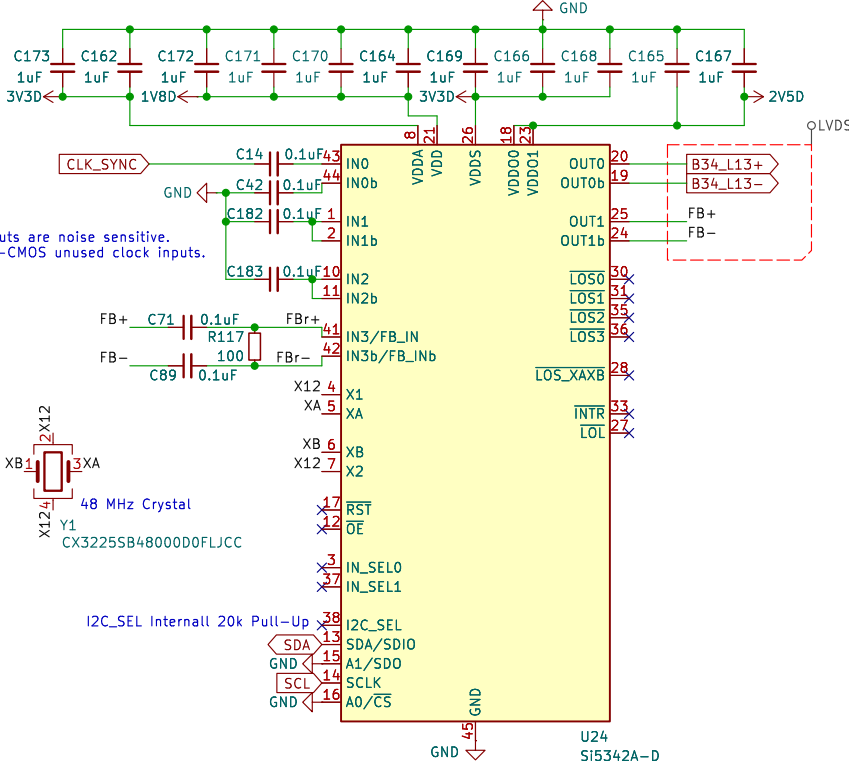
Floating clock inputs are noise sensitive.
Add a cap to non-CMOS unused clock inputs.
